**Report: Deficiency Report**  
**Function: Test, Adjust, & Balance**  
**Date: 02/17/2026**  
**Completed By: National TAB**

## 02-16-26 WHATABURGER #1687 LUTZ, FL

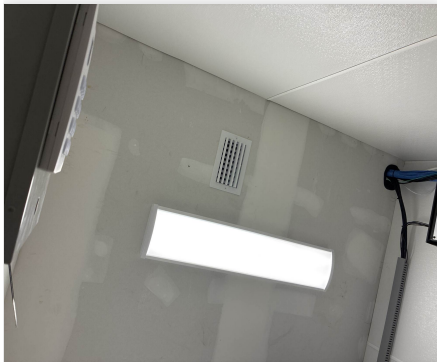
**Issue Name :** Additional Diffuser - RTU 3 office  
**Description :** An additional diffuser was installed in office. There was an existing supply flex duct run blowing above ceiling in which the MC tapped into. Currently, damper is fully closed and grill reads 75 CFM. Unable to balance without a CFM target. Recommend engineer review.  
**Created By :** National TAB                      **Assigned To :** National TAB - Will Turnbough  
**Status :** Open  
**Priority :** Urgent                                      **Asset Tag :**  
**Originated Date :** 02/19/2026 - Jackson Gunnels - National TAB

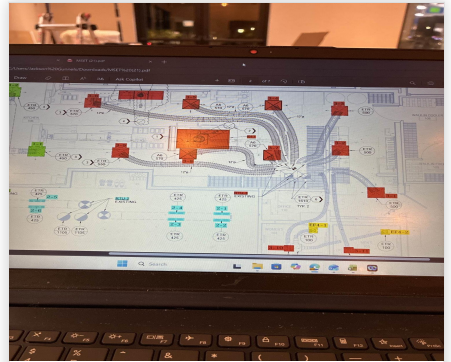
**Issue Name :** Exhaust fans - Incorrect Locations  
**Description :** Exhaust fans are mounted on wrong curbs. Unable to balance fans in current state. EF-1 (larger fan) also leaks around curb.  
**Created By :** National TAB                      **Assigned To :** National TAB - Will Turnbough  
**Status :** Open  
**Priority :** Urgent                                      **Asset Tag :**  
**Originated Date :** 02/19/2026 - Jackson Gunnels - National TAB

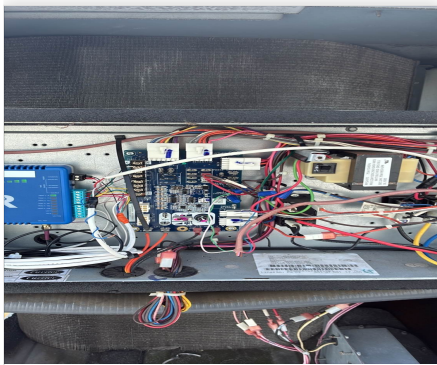
**Issue Name :** Restroom supply dampers  
**Description :** Parallel blade dampers installed in restroom supply only reduce airflow by half when fully closed, recommend OBDs be installed.  
**Created By :** National TAB                      **Assigned To :** National TAB - Will Turnbough  
**Status :** Open  
**Priority :** Urgent                                      **Asset Tag :**  
**Originated Date :** 02/19/2026 - Jackson Gunnels - National TAB
